To: Vertical Express Impact Clients
From: CEC Technical Support
Subject: HPU to TKE Fixture Breakout Board Cables
Bulletin: #22

Figure #1: HPU to TKE Breakout board cable sent with fixtures. **DO NOT USE!!!!**

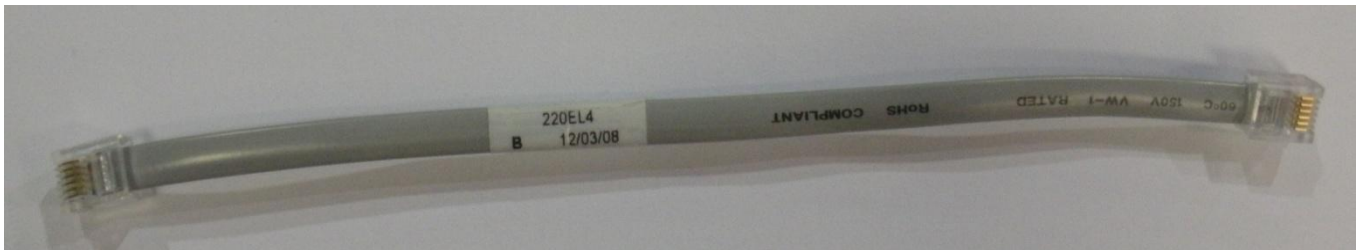
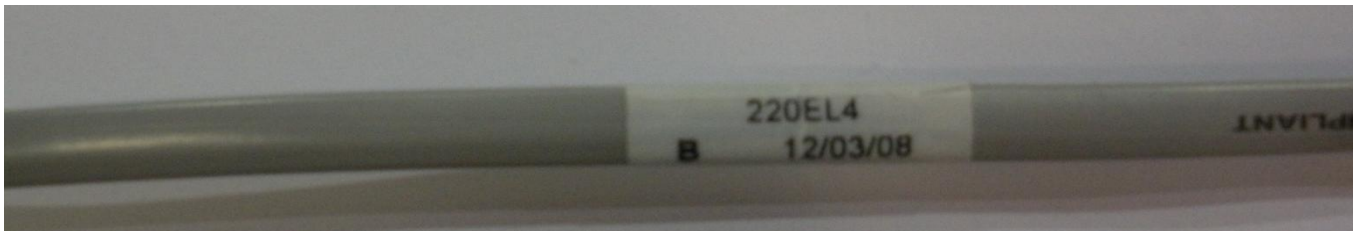
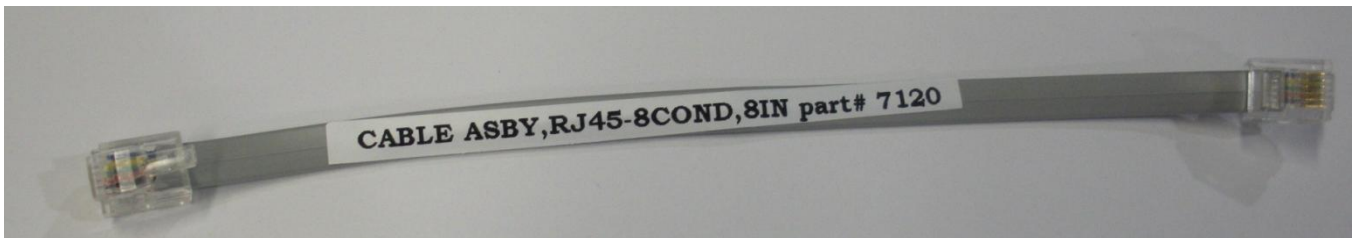
It has come to our attention that the cable supplied by TKE has been causing issues with the CEC HPU serial hall call boards. As a result, CEC will be sending out the correct cable required for the HPU to TKE breakout boards.

Please ensure you **DO NOT** use TKE cable #220EL (figure #1). Use the supplied CEC cable #7120 instead (figure #3)

Figure #2: Closer look on TKE supplied cable. **Note:** part number 220ELx. **DO NOT USE!!**

CEC will also include a software fix to prevent any issues concerning cable on all future shipments. This software fix will prevent any damage to the HPU.

Figure #3: CEC replacement cable (part # 7120). **USE THIS CABLE FOR HALL BOARDS.**
